**CRITIQUE OF DOE'S NEAR-FIELD ENVIRONMENT
MODELING FOR THE PROPOSED HIGH-LEVEL
NUCLEAR WASTE REPOSITORY
AT YUCCA MOUNTAIN, NEVADA**

**Nuclear Regulatory Commission
Contract NRC-02-93-005**

**Center for Nuclear Waste Regulatory Analyses
San Antonio, Texas**

February 1997

Figure 2-3. Enrichment factor for chloride at 100 y plotted as a function of depth computed using MULTIFLO compared with the simple evaporation model. See text for explanation.

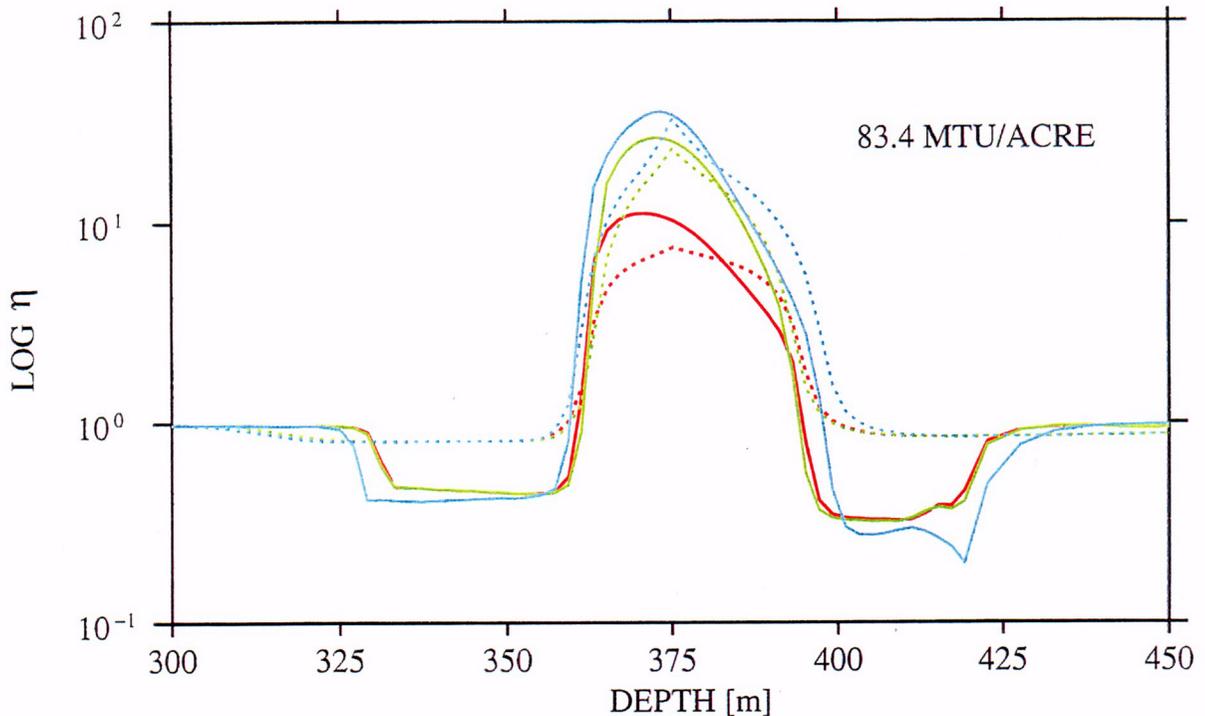
The enrichment factor for chloride predicted by MULTIFLO is compared to the ratio of the initial liquid saturation to the liquid saturation at the same time and location, as given in Eq. (2-6). The latter corresponds to the enrichment that would be obtained if only pure evaporation is taken into account, equivalent to results obtained using the computer code EQ6. Two different residual saturations s_r^r of 0.08 and 0.01 are considered. The residual saturation occurs as a parameter in the van Genuchten relations for saturation and relative permeability in terms of capillary suction (van Genuchten, 1980). Physically the residual saturation, also referred to as the irreducible or equilibrium saturation, represents the threshold liquid saturation at which the liquid phase becomes disconnected, breaking up into isolated islands of liquid water. At and below the residual saturation, the liquid relative permeability becomes zero and flow is not possible. The liquid saturation may be reduced below the residual value by evaporation with water carried away in the vapor phase.

In figure 2-3 the enrichment factor for chloride is displayed as a function of depth for an elapsed time of 100 y, and in figure 2-4 as a function of time at the repository horizon. Three cases are examined. The base case (red curves) corresponds to the parameters listed in table 2-2. The green curves correspond to a residual saturation of $S_1^r = 0.001$, and the blue curves to a residual saturation of $S_1^r = 0.001$ and a fracture permeability of $10^{-11} m^2$. The solid curves correspond to the MULTIFLO calculations, and the dotted curves to the pure evaporative estimate. Increasing the fracture permeability or reducing the residual saturation leads to an increase in the chloride enrichment factor. As can be seen from the figures, the pure evaporative enrichment factor closely matches the MULTIFLO calculated value. In the regions of condensation above and below the repository where the aqueous solution becomes more dilute, the pure evaporation enrichment factor exceeds the MULTIFLO calculated value. This difference in behavior can be attributed to dilution of the total inventory by the flux of condensate fluid. This factor is not accounted for in the pure evaporation calculation. At early times, the flux adds solute species to the control volume, whereas at later times, because the refluxing fluid is more dilute than the ambient groundwater concentration, a reduction in the enrichment factor ensues.

It is apparent that pure evaporation calculations alone are insufficient and relatively limited in their ability to bound the aqueous and gaseous phase compositions that would result from extended boiling and evaporation of liquid water in the near-field region of the repository. Mechanisms responsible for determining how the solute concentration changes with changing temperature and moisture content include both boiling and evaporative effects and reflux of liquid water including infiltration. There are two cases to consider: the first case corresponds to a heat load for which complete dryout does not occur; and the second case to a heat load for which complete dryout does occur. In the first case, the enrichment factor for a nonreactive species such as chloride is roughly equal to the amount of water evaporated. Saturation of chloride with halite or other chloride-bearing minerals is presumed not to occur and, therefore, in this case a simple evaporation model may be used. What is needed is a TH calculation providing the liquid saturation, which determines the amount of water evaporated. As evaporation proceeds, the liquid saturation will eventually fall below the residual saturation for the medium assuming there is sufficient heat supplied by the spent nuclear fuel and infiltration is sufficiently low. For saturations at or below the residual saturation, the aqueous phase consists of isolated islands of liquid and as a result the liquid flux becomes vanishingly small because of the small liquid relative permeability. Thus, under these

Figure 2-4. Enrichment factor for chloride at the repository horizon plotted as a function of time at the repository horizon computed using MULTIFLO compared with simple evaporation model. See text for explanation.

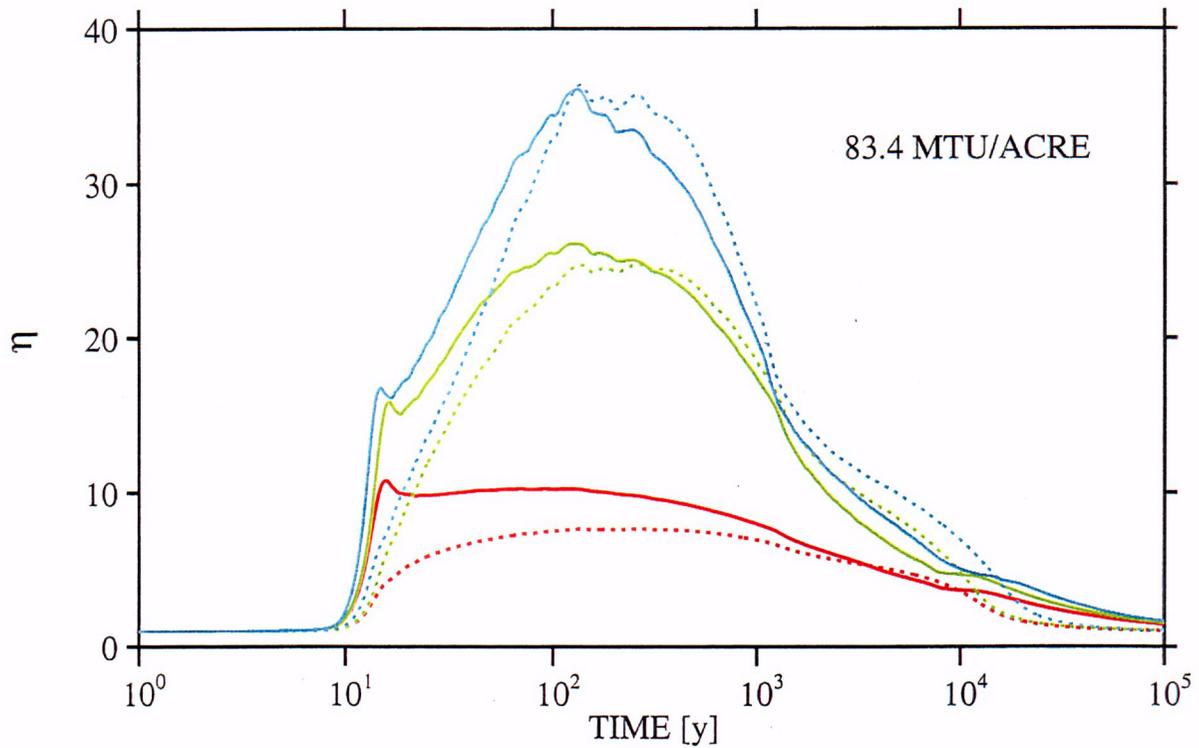
circumstances, regions of extreme dryout which are below the residual saturation act as closed systems with respect to flow of liquid. The vapor phase, however, is free to move throughout these regions.

The second case, however, is more complicated. In this case, all dissolved species precipitate out as salts during complete dryout, and then redissolve as the rewetting phase takes place. Therefore, the solution concentration is determined by the amount of water present during the rewetting phase—not on the amount of water evaporated. Thus it is the rate of reflux of water, including the contribution from infiltration at the surface, into the dryout zone which is most important. This quantity lies outside the scope of EQ6 calculations. Because the rate of rewetting proceeds much more slowly compared to dryout, much larger concentrations can be expected during the rewetting phase. For this case, EQ6-type calculations which consider evaporation only and predict the stable mineral assemblage at complete dryout,

provide *no* information whatsoever regarding the solution composition during the rewetting phase. Knowing the extent of resaturation, it may be possible to run EQ6 calculations in reverse and obtain the solution composition resulting from adding liquid water to the mineral precipitate obtained during dryout. However, this has not yet been done to the authors' knowledge. In essence, this is what the computer code MULTIFLO accomplishes by combining a reactive transport calculation with a thermal-hydrologic calculation to determine the temperature, liquid saturation, aqueous and gaseous compositions, and mineral deposition profiles with time. Such calculations are currently in progress for the complete dryout case.

Figure 2-6. Log permeability enhancement factor plotted as a function of the exponent in Eq. (2-12) for the alteration of cristobalite to quartz. The solid line is for an initial cristobalite volume fraction of 0.14, and the dashed line 0.39 used by Johnson and Glassley (1996).

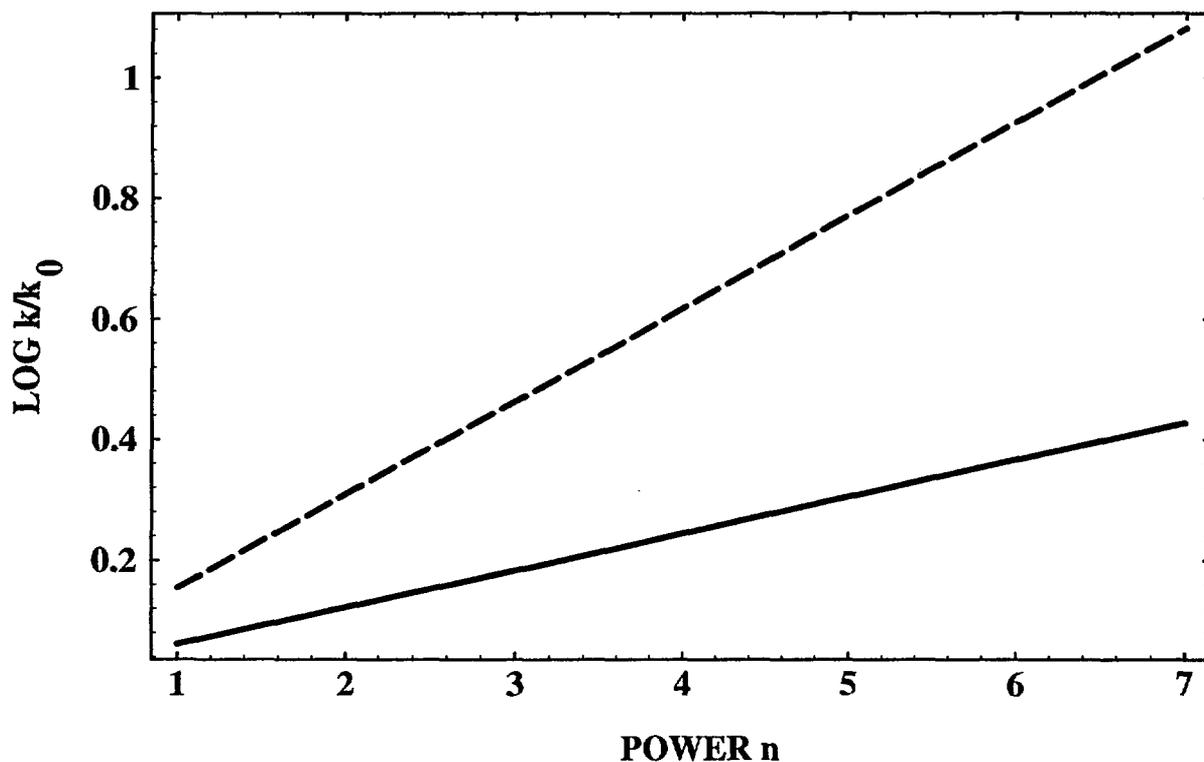
As noted by Johnson and Glassley (1996) the transformation of cristobalite to quartz creates porosity as a result of the larger cristobalite molar volume compared to quartz. However, the volume fraction used for cristobalite seems too high by roughly a factor of two compared to observed mineral abundances (see figure 2-5). This would enhance the change in porosity compared to lower and more reasonable initial cristobalite concentrations. The increase in porosity is proportional to the cristobalite volume fraction as given by the expression

where κ_0 and ϕ_0 refer to the initial permeability and porosity, respectively, and n is a constant. Shown in figure 2-6 is a comparison of the resulting change in permeability for complete alteration of cristobalite to quartz for the initial volume fraction for cristobalite given by Johnson and Glassley (1996) (0.39) and the value taken from figure 2-5 (0.14), plotted as a function of the exponent n .
